**PROJECT NO. ST87600114-3
GRAND CANAL BIKE AND PEDESTRIAN IMPROVEMENTS
FEDERAL AID NO. PHX-0(BFG)F**

ADDENDUM NO. 7

ISSUE DATE: October 4, 2017

DES: JL	DR: JKA	CK: RCA	SHEET NO:	TOTAL SHEETS
DATE: 07/17	DATE: 07/17	DATE: 07/17	2.012	2.182
SCALE: 1" = 20'		0" = 20'

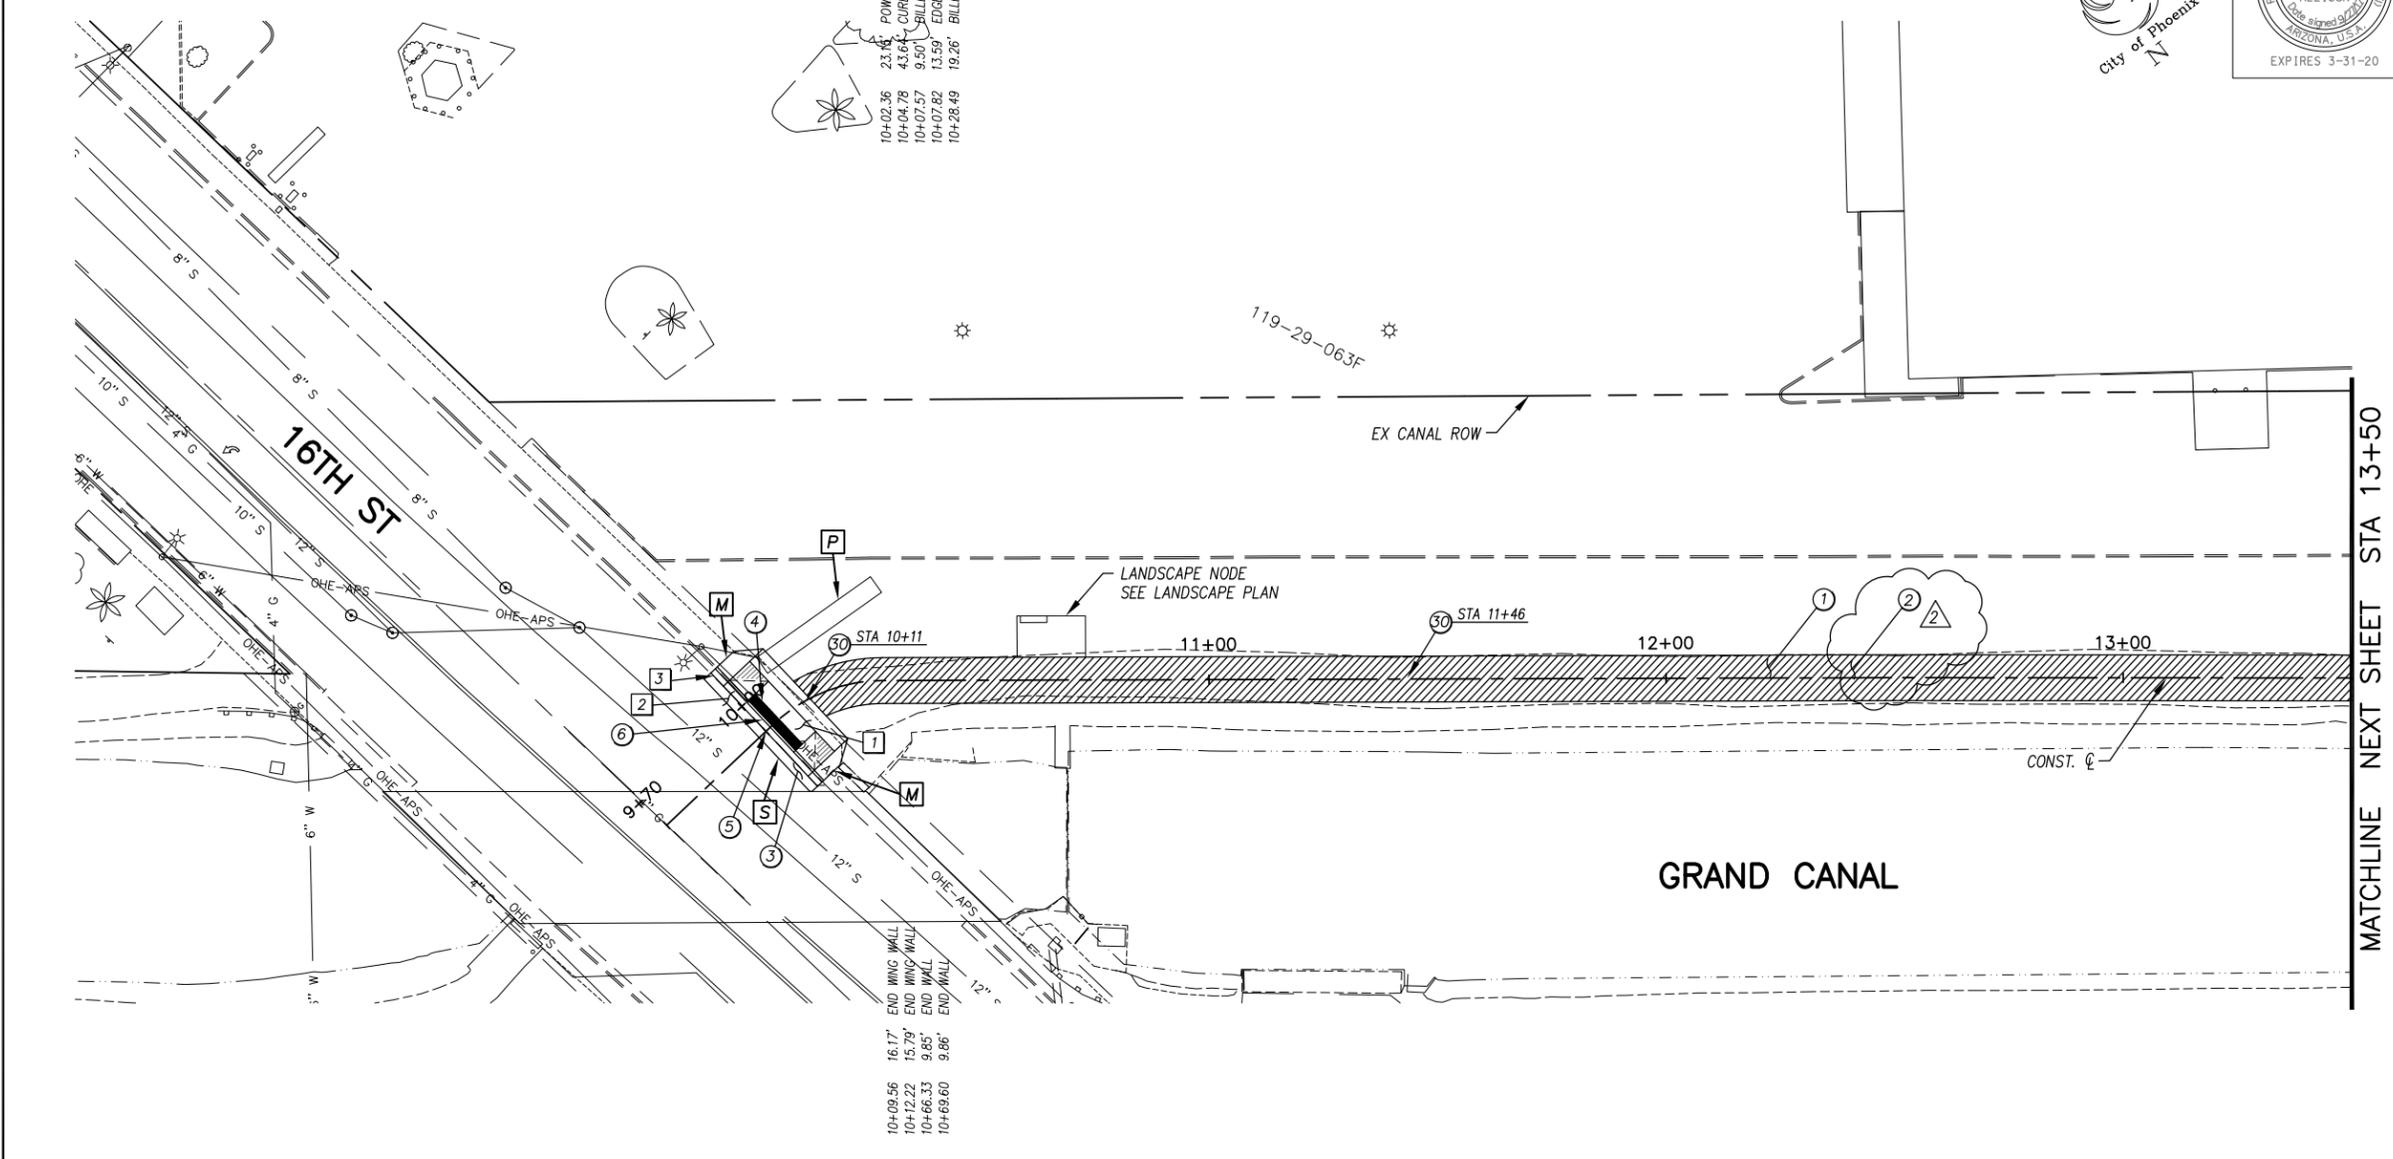
1. Replace sheet 2.003 with Sheet 2.003 REV.
2. Replace sheets 2.012 to 2.052 with Sheets 2.012 to 2.052 REV.
3. Replace landscape sheets 1.29; 2.101; and 3.52 with revised sheets 1.29; 2.101 and 3.52 REV 10/2/2017 (revisions to post fence detail/schedule).
4. Replace landscape sheets 2.127 and 3.68 with 2.127 and 3.68 REV 10/2/2017 (revisions to landscape legend).
5. An entire legible set of Segment 2 landscape sheets are attached. Revised Segment 2 sheets for post fence and landscape legend are included in entire legible set of Segment 2 landscape sheets.
